# UNITED STATES PATENT AND TRADEMARK OFFICE

10/577,118

<b>Office Action Summary</b>	<b>Application No.</b> 10/577,118	<b>Applicant(s)</b> CROSSMAN, ARTHUR W.	
	<b>Examiner</b> Manuel A. Mendez	<b>Art Unit</b> 3763

### DETAILED ACTION

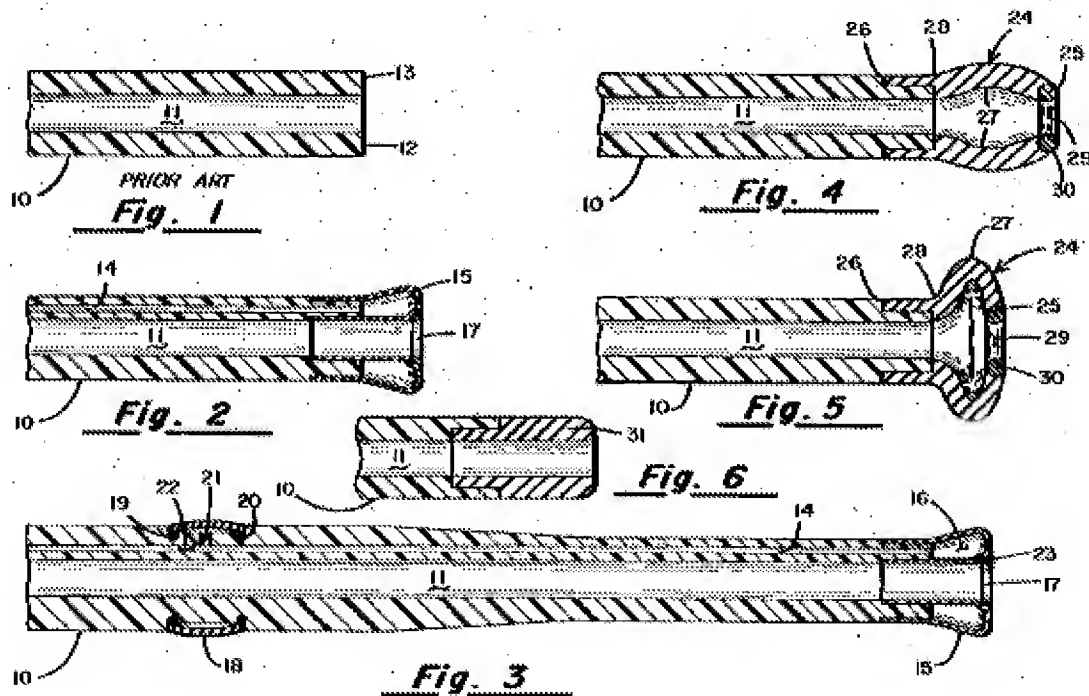
**Claims 1, 3, and 4 are rejected under 35 U.S.C. 102(b) as being anticipated by Van Tassel et al. (US 4,531,943; hereafter Van Tassel).**

The Van Tassel patent shows in the figures above, a catheter shaft having a proximal portion and a distal portion, and a distal tip disposed on the distal portion, the distal tip having a blunt shape. In relation to claim 3, distal tip (13) is inflatable. In relation to claim 4, figure 4 shows an olive shape distal tip.

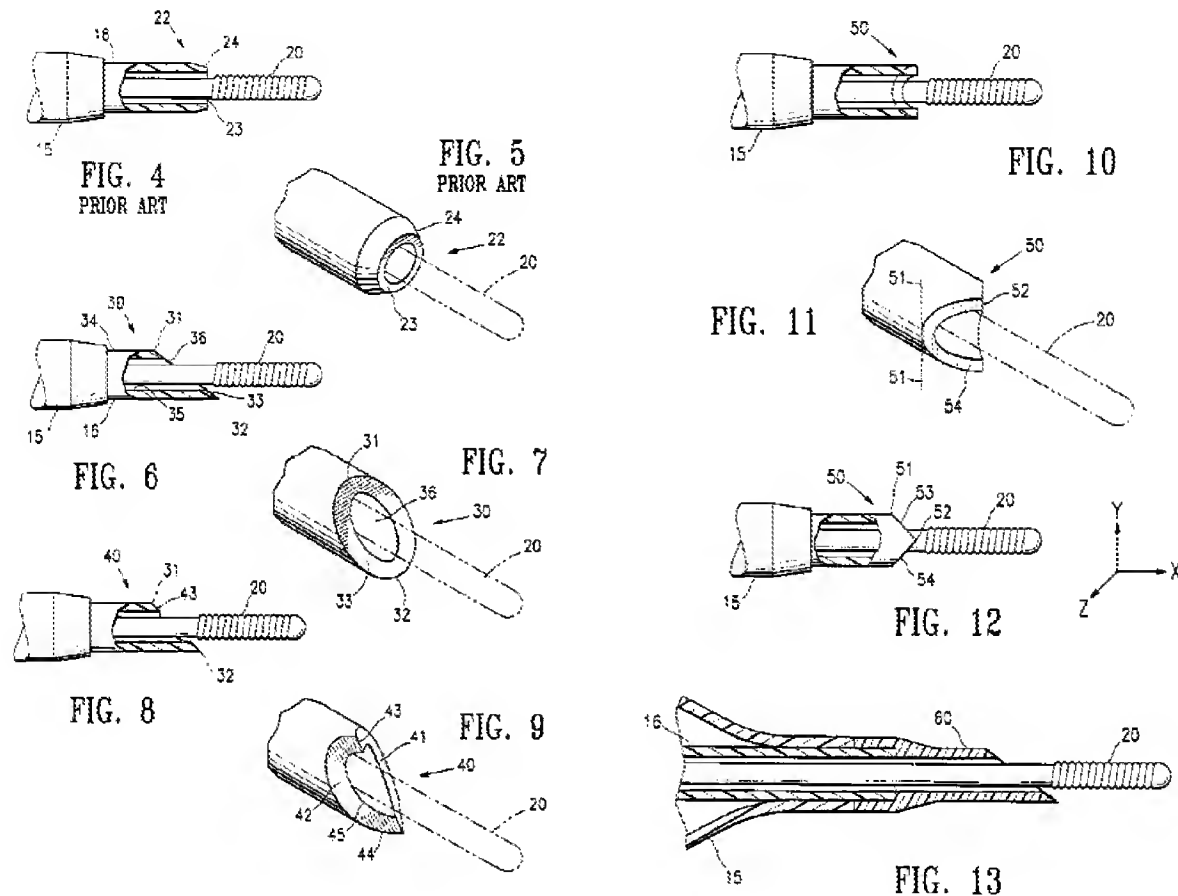
**Claims 5-21** are rejected under 35 U.S.C. 103(a) as being unpatentable over **Van Tassel et al.** (US 4,531,943; hereafter Van Tassel) in view of **Lee** (US 6,206,852).

As stated in the previous Section 102 rejection, Van Tassel discloses a set-back extension having an olive shape (claim 14). In the figures above, the Lee patent shows a set-back extension (claim 5), blunt shapes to avoid trauma (claim 6), a tapered set-back extension (claim 7), a set-back extension having a semi-elliptical shape (claims 8, 15, 19, 20), a tip that can be manipulated and that is blunt to avoid trauma (claims 9, 16, 17, 18), a balloon that is inflatable with a pre-formed shape (claims 10, 11, 21), an
